MADERA COURTRROOM BUILD-OUT
200 SOUTH G. STREET
MADERA, CA 93637

WALL SECTION

A4.0

WALL SECTION - RECEPTION AREA 327C

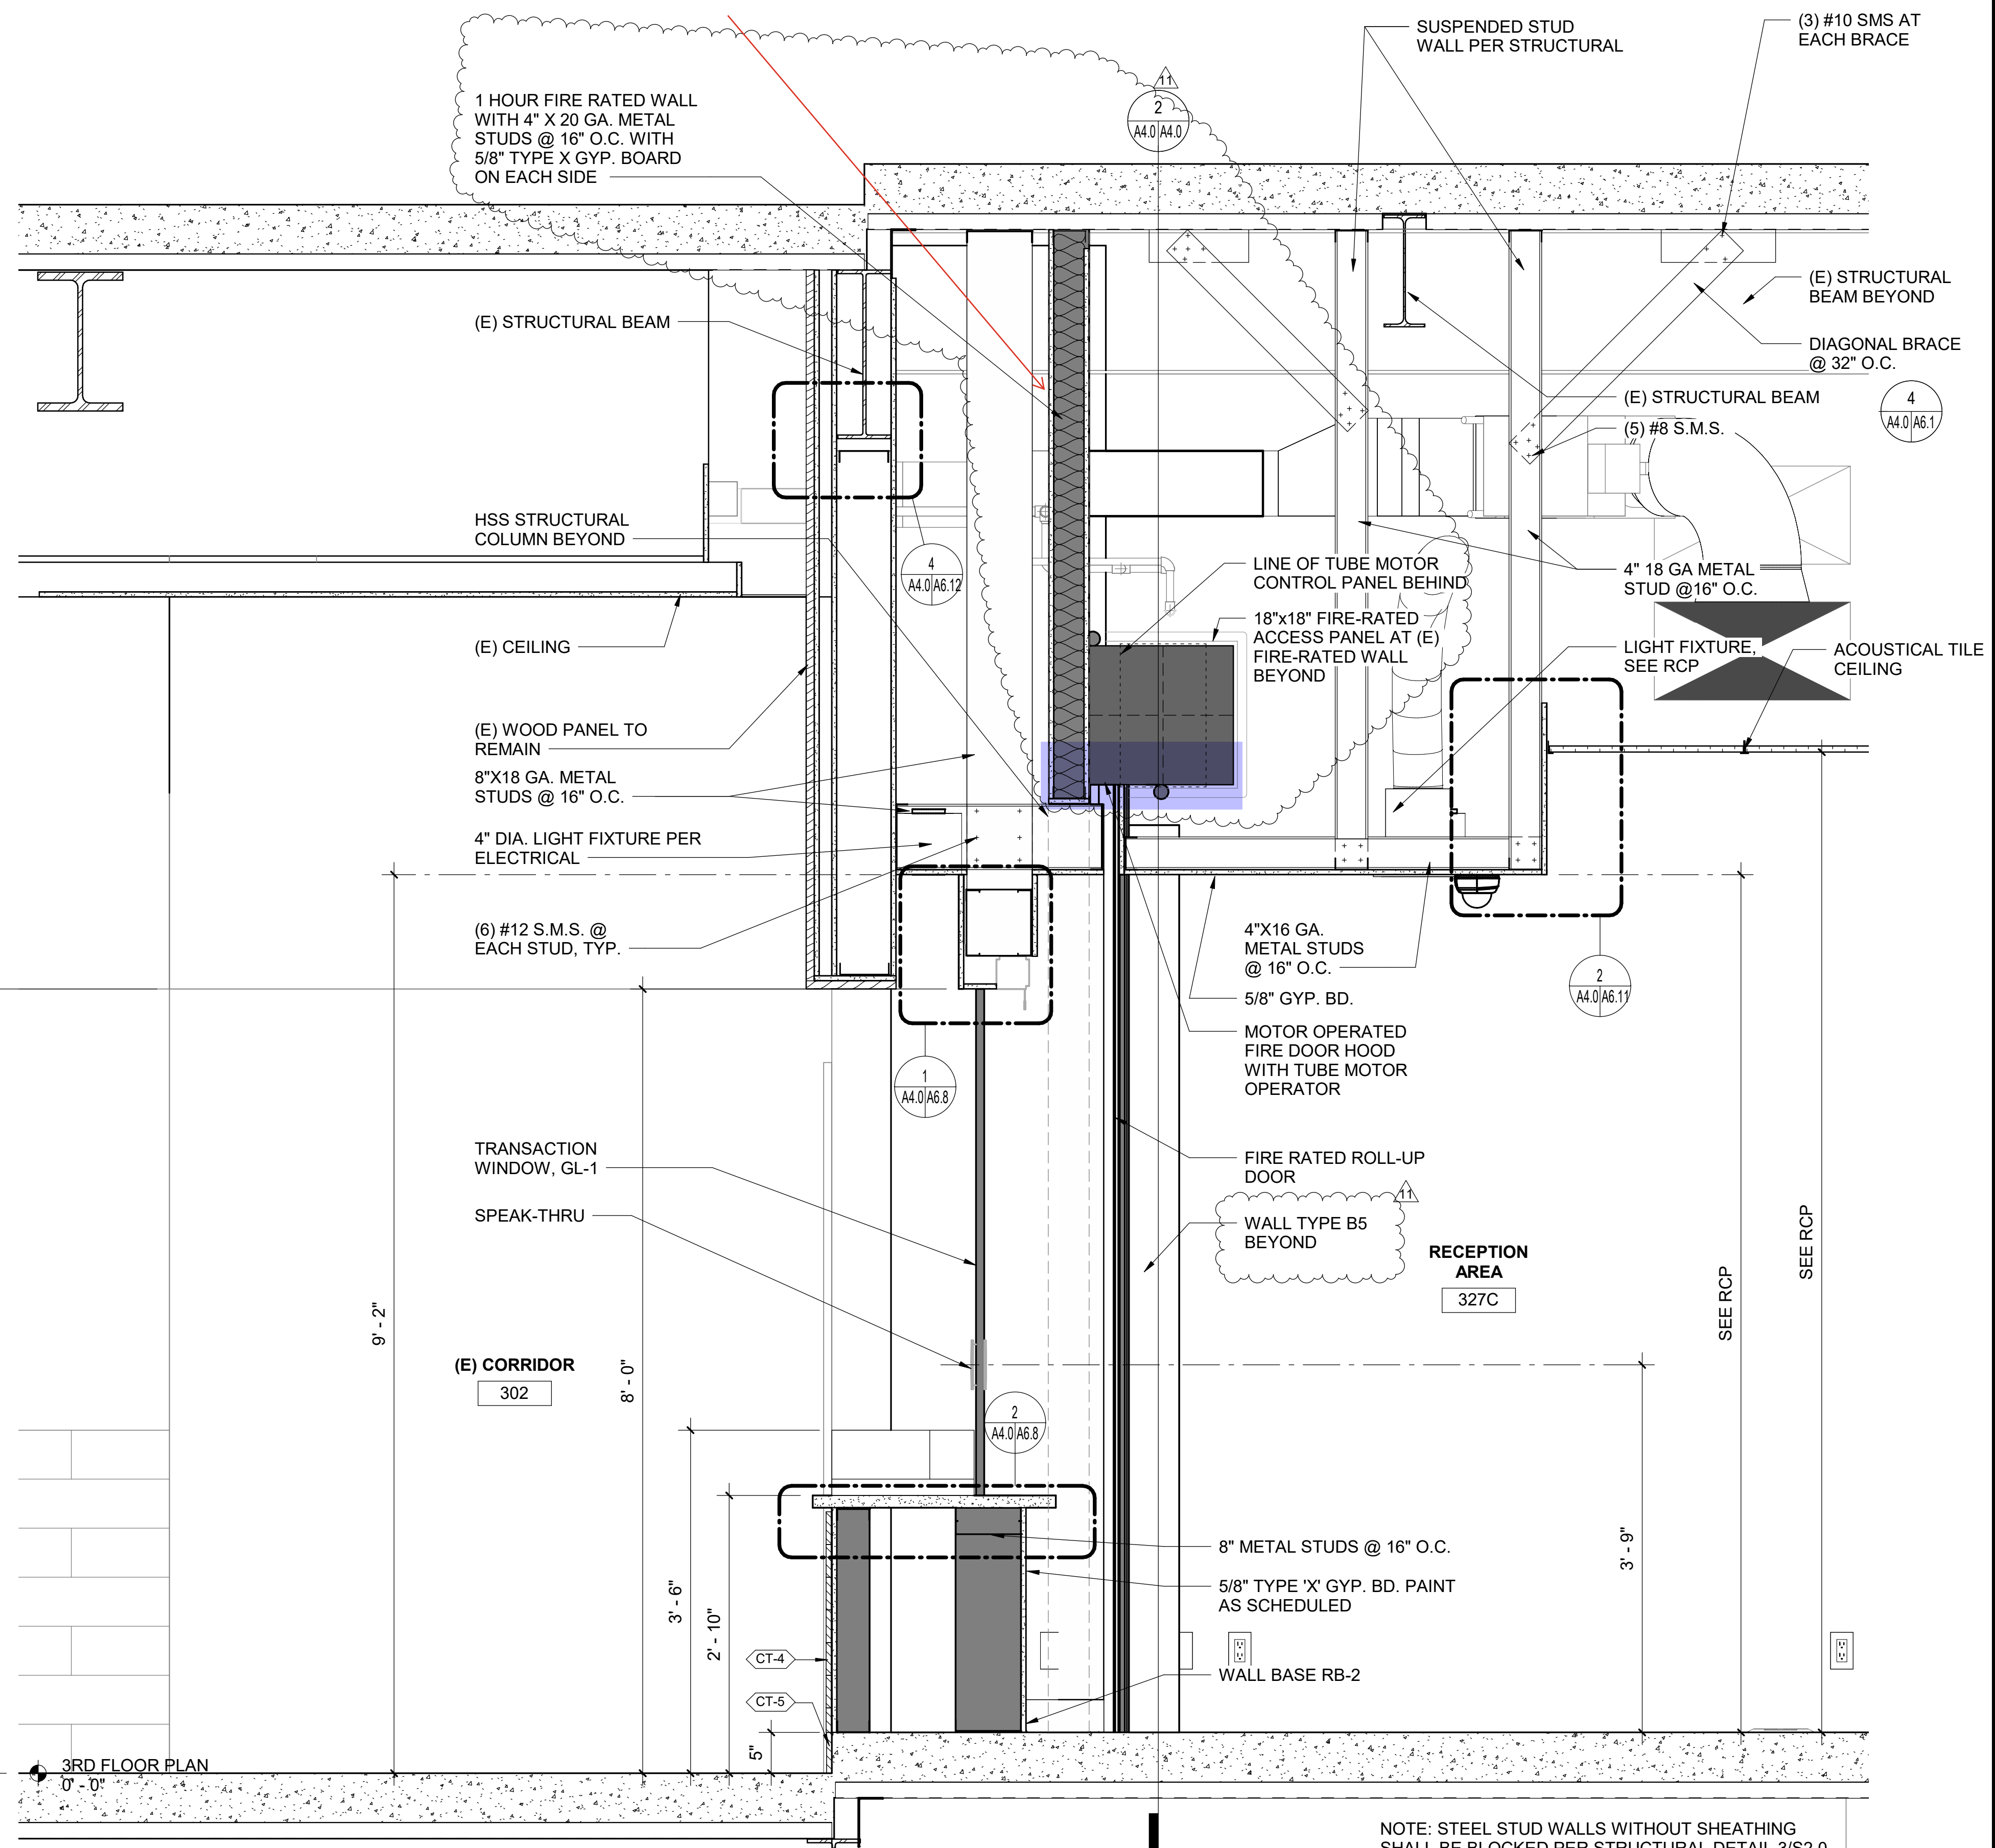
Provide UL Wall design for the wall proposed at this location
